ADDENDUM

Addendum No.: 3

Project Name: I-5 Pump Station and Force Main Upgrades

Date: July 26, 2021

Item 09 - Drawings – FM-8

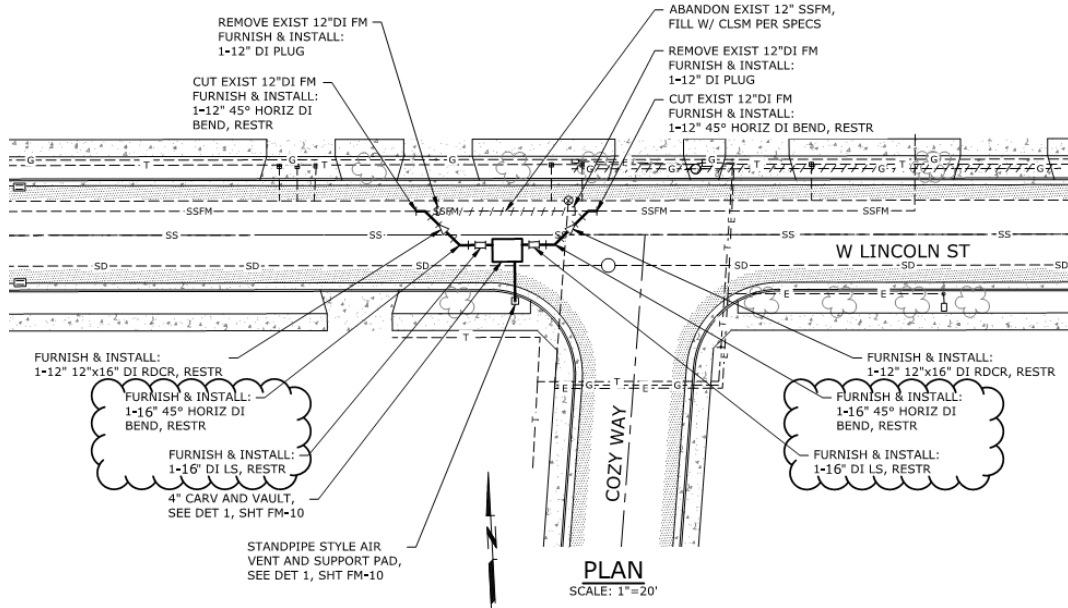
2) **REPLACE** the pipe callouts in the revision clouds as shown below:
